Planning Memorandum

Re: **2570 Delaware Avenue – Major Site Plan Review, Conditional Use Permit and Variances**
WSB Project No. 024203-000

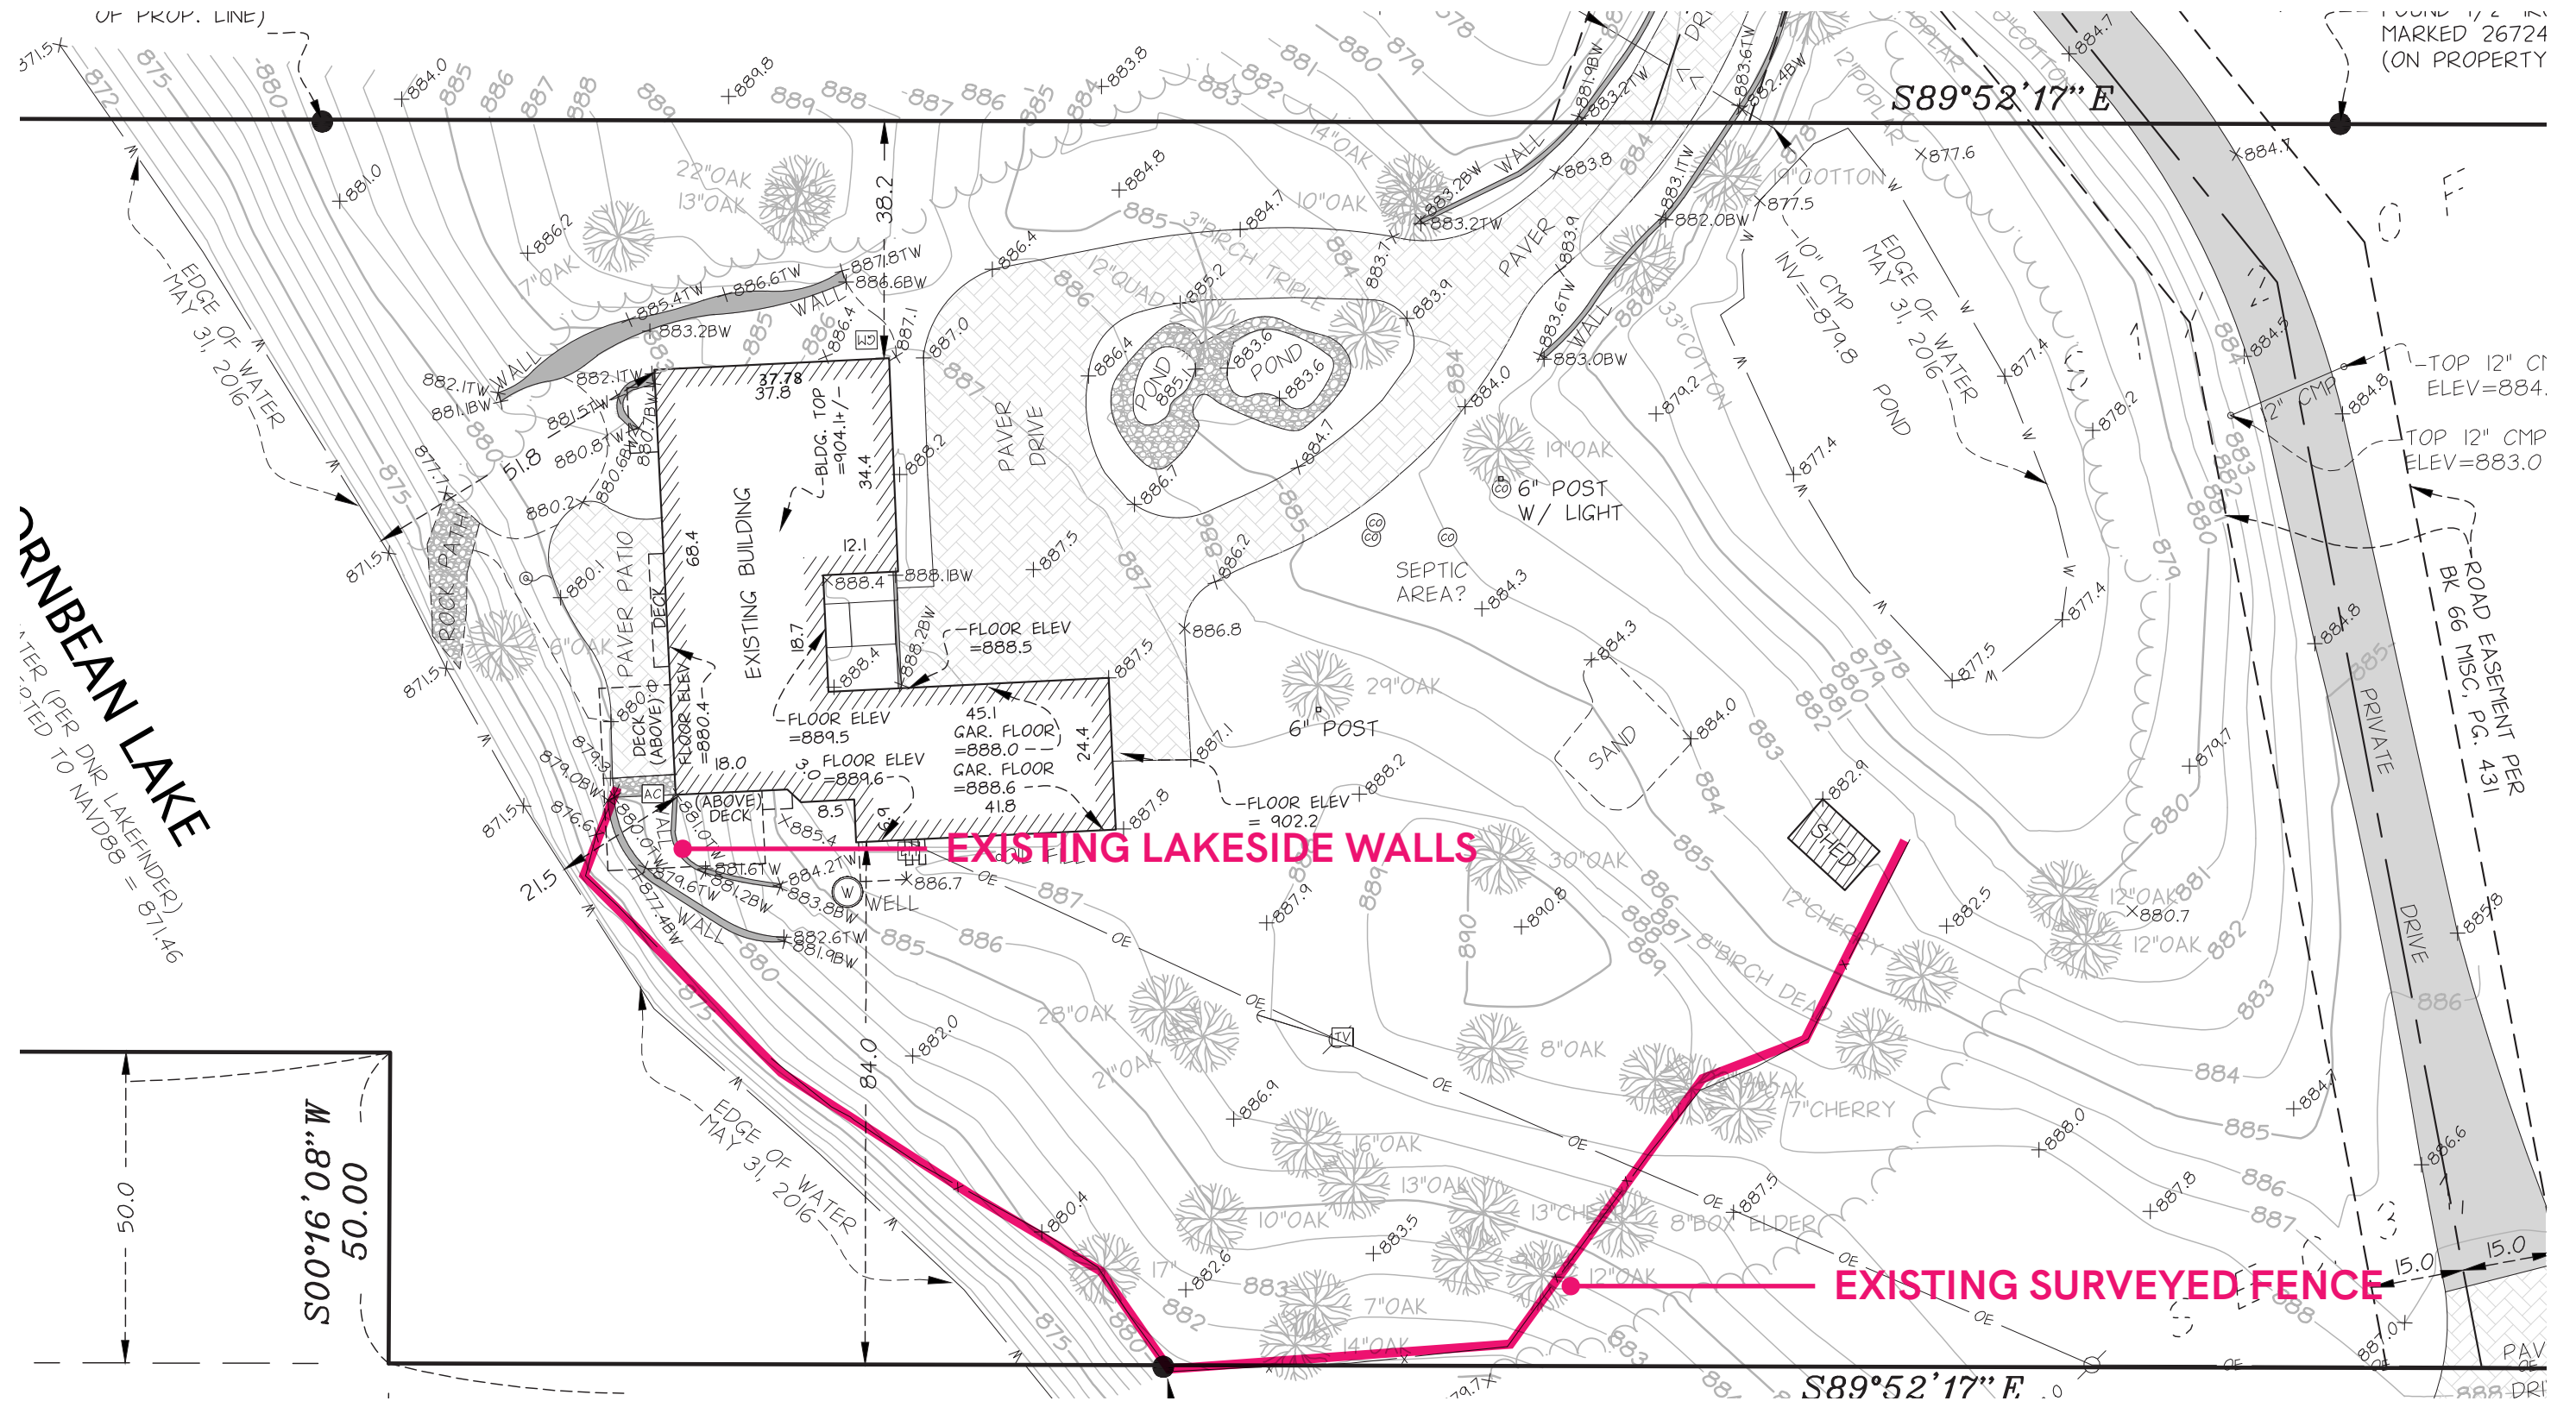
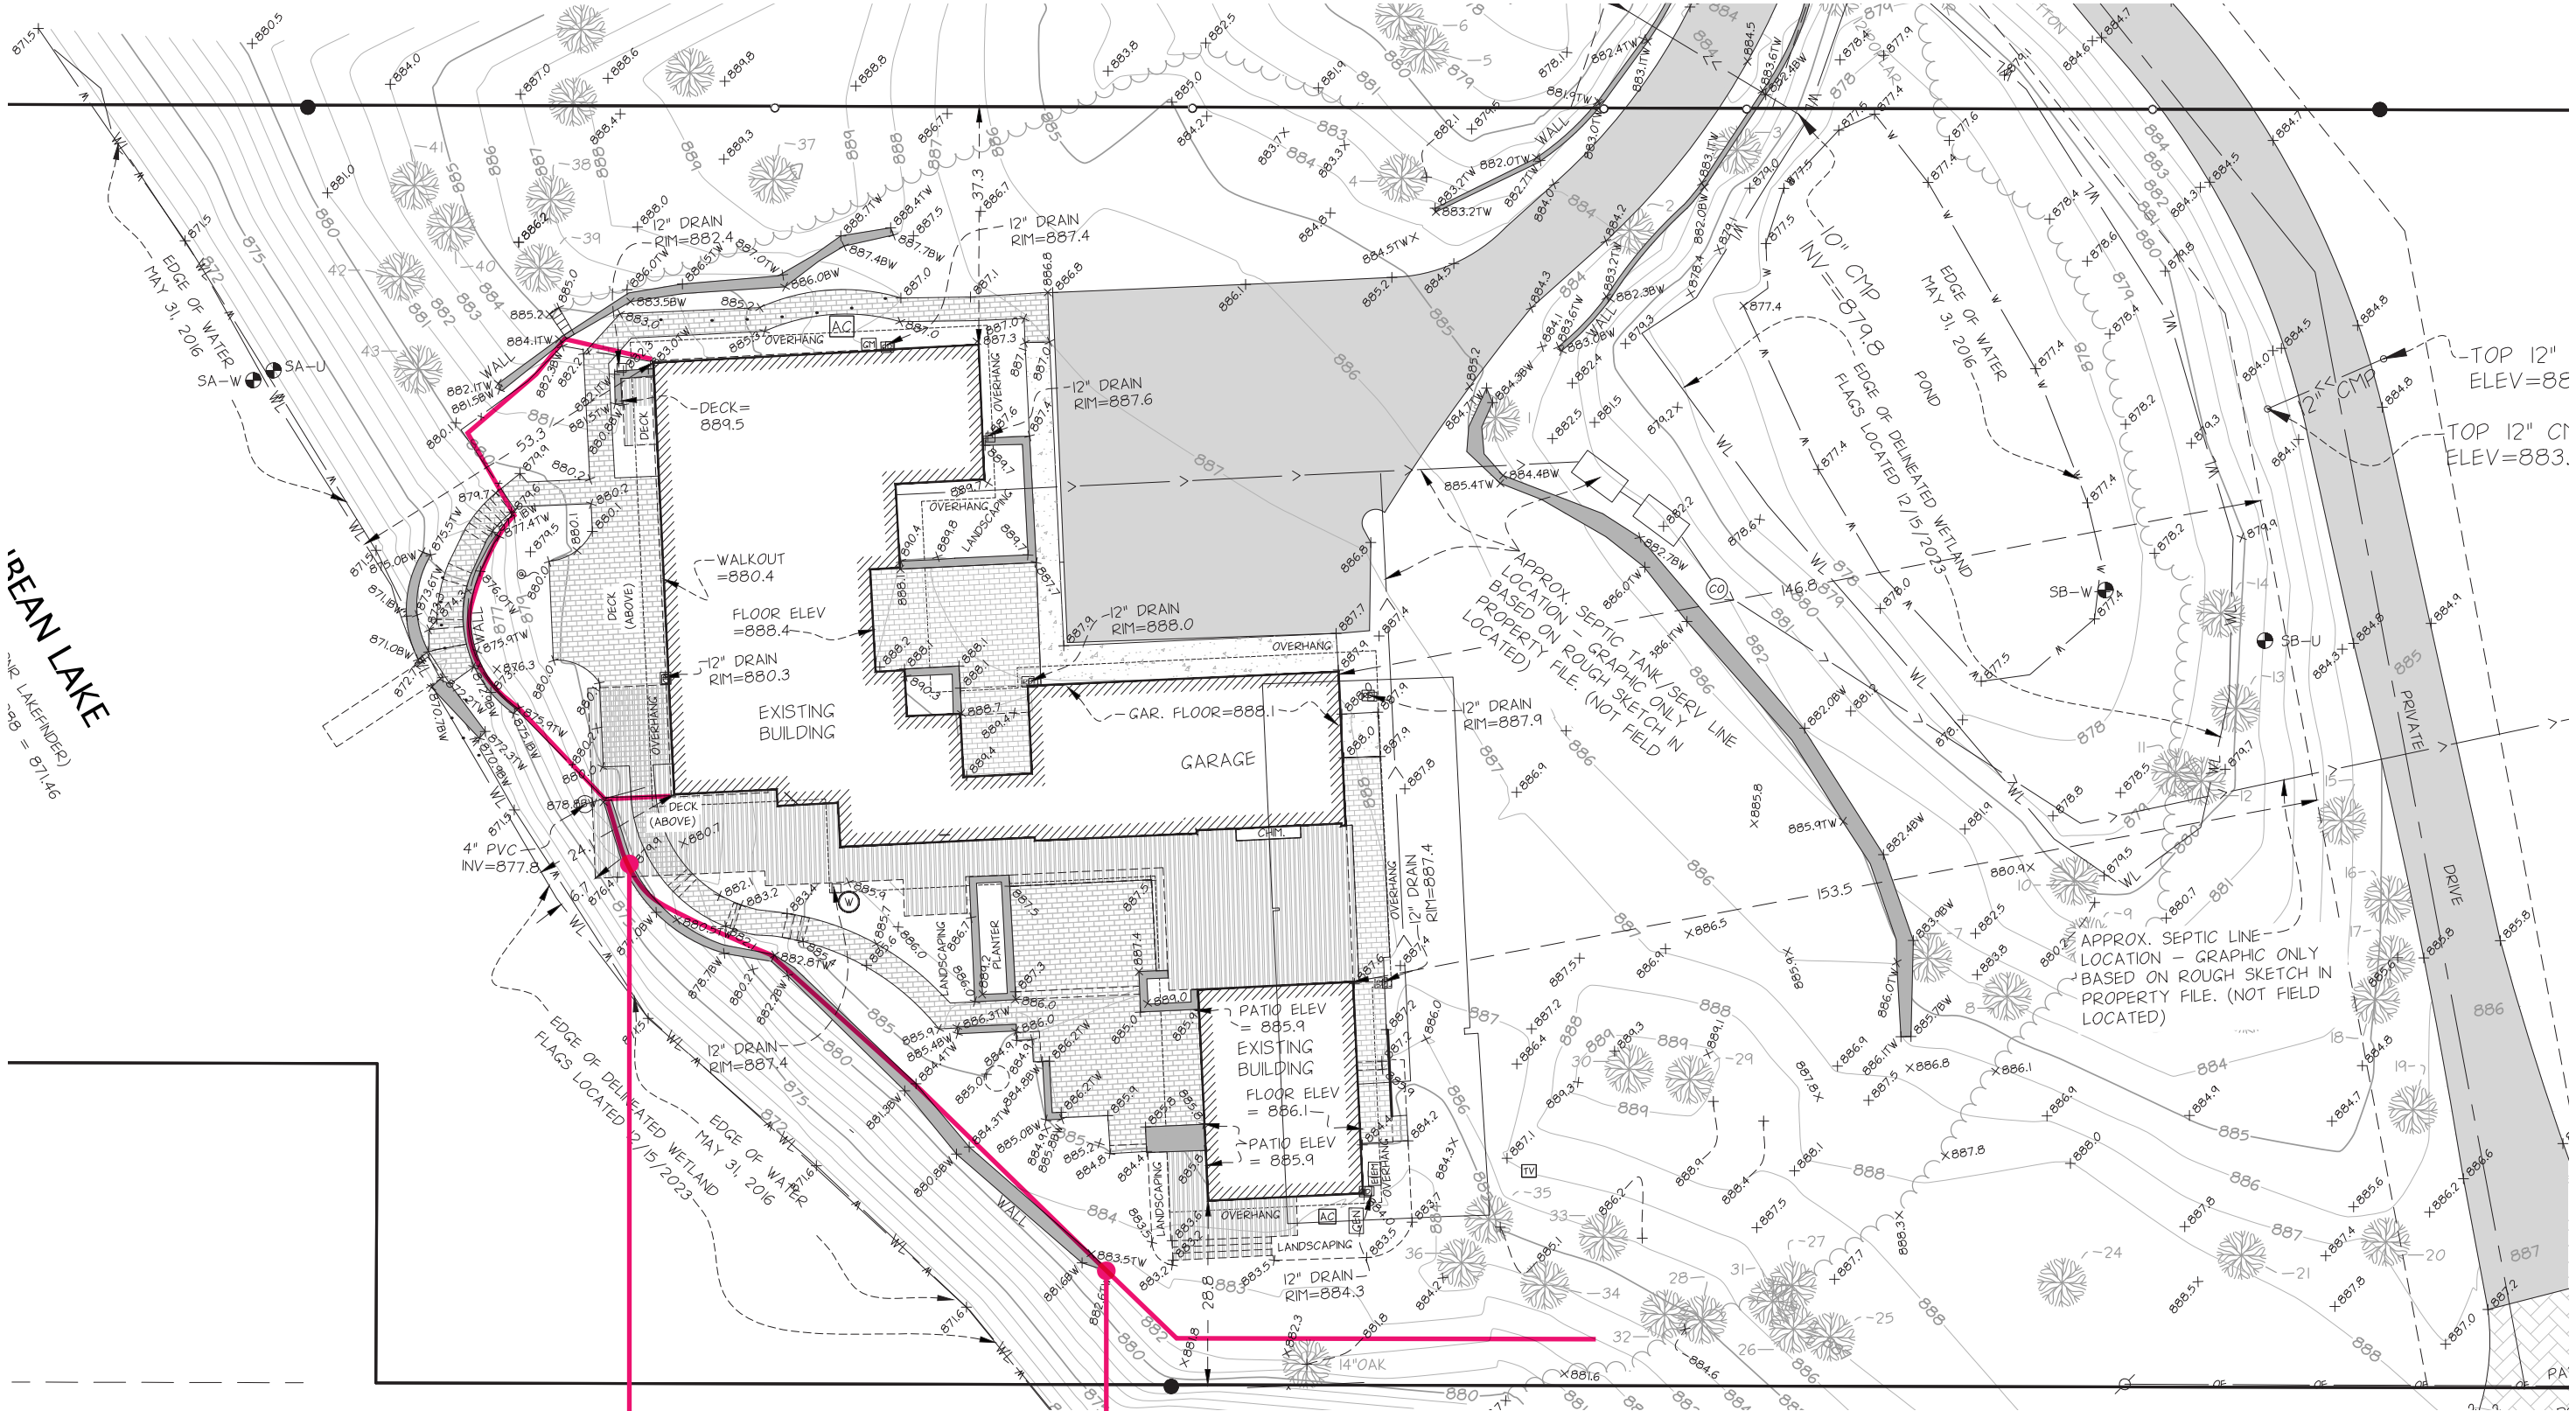
PLEASE CONSIDER THE SAFETY REQUIREMENTS AND CHALLENGES OF A HOUSE SO CLOSE TO THE LAKE. THIS STRUCTURE IS CLOSER TO THE LAKE THAN ANY OTHER ON THIS LAKE.

THIS REQUIRES SLOPE STABILIZATION AND REQUIRED GUARDRAILS IN MANY LOCATIONS.

MASONRY WALL - HIGHLY CRITICAL TO STABILIZE GRADE, OVER 4' DROP - FENCE IS REQUIRED BY BUILDING CODE
